NOBLE DENTON MARINE SERVICES - HORNSEA 3 WIND FARM REVIEW OF MARINE HAZARDS (NOVEMBER 2018)

HORNSEA 3 WINDFARM

Review of Marine Hazards

Report No.: A13423, Rev. 3

Figure 4-4: Hornsea Three shipping and navigation study area (ref: Chapter 7 Environmental Statement Volume 2 – Infrastructure and other users)

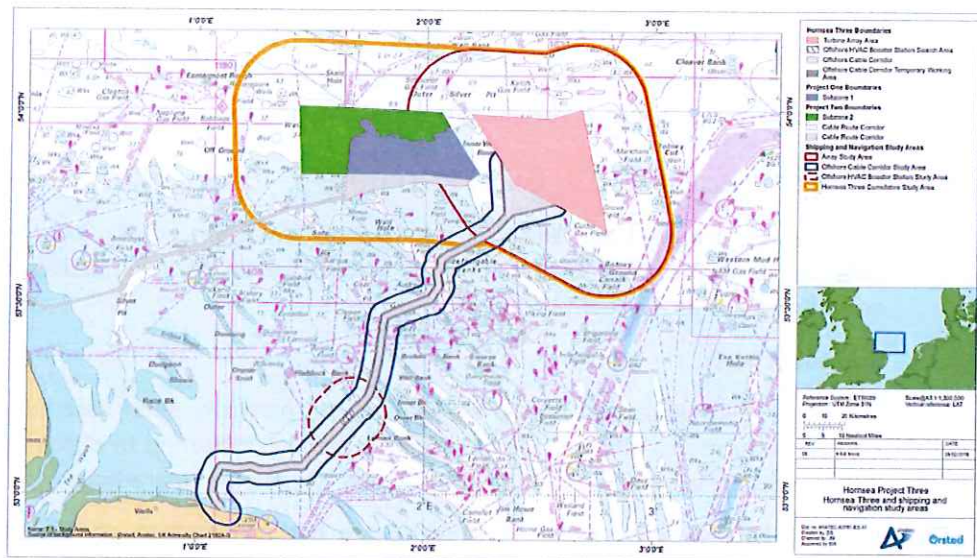
In relation to this document it is noted:

- Para 7.7.2.3 (Commercial Vessel Analysis) states that oil and gas vessels servicing drilling rigs were excluded from the analysis whilst vessels supporting permanent installations were retained. As many operators use the same vessels to support all activities this distinction could be misleading;

Fig 4-5: Fishing activity in the study area of the proposed wind farm (ref: Chapter 7 Environmental Statement Volume 2 – Infrastructure and other users)

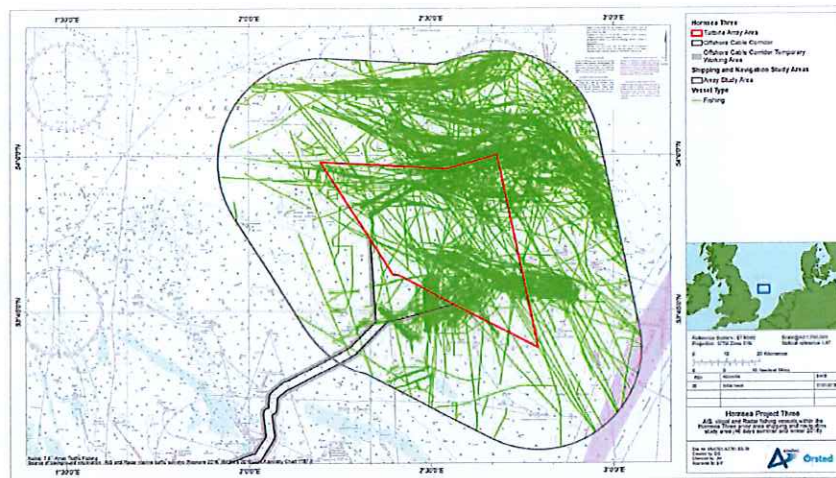
- In relation to fishing activity, it can be seen from the document that considerable fishing operations are prosecuted both in and to the East of the array area, in the vicinity of the Markham area. No meaningful assumptions or assessment has been made as to the displacement effect on this activity at any stage of the proposed windfarm, or the effect on Spirit Energy assets or operations;

This document does not address the potential navigation and collision impacts of construction, O&M and de-commissioning activity associated with the proposed wind farm in detail. This is of particular concern in relation to displaced vessels (cargo and fishing) on the assets and operations of Spirit Energy in the Markham area.

Figure 4-6: Study area indicating Blocks where Spirit Energy (SE) are designated as Operator (ref: Chapter 11 Environmental Statement Volume 2 – Infrastructure and other users)

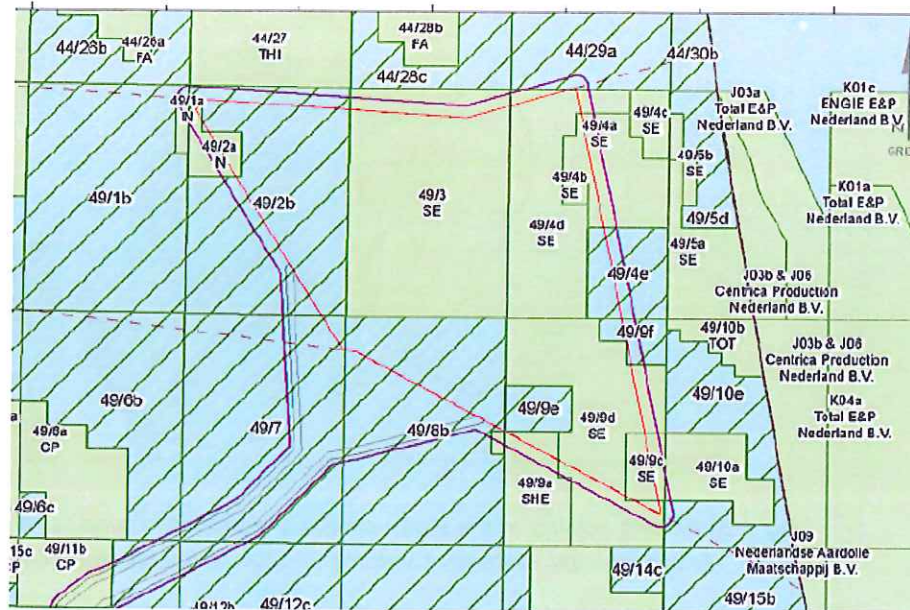
As shown elsewhere in this study, 1 km is an inadequate separation for a number of oil and gas activities including Jack up Rig Moves, and Crane Vessel spread mooring hence the EIA does not address hazards associated with current Spirit Energy activities of this nature.

- Safety zones of 500m, and advisory safety zones of 1,000m may interfere with oil and gas activity. However, the detail of how these zones may interfere with operations at Spirit Energy assets, especially in the Markham area, is not addressed in detail;
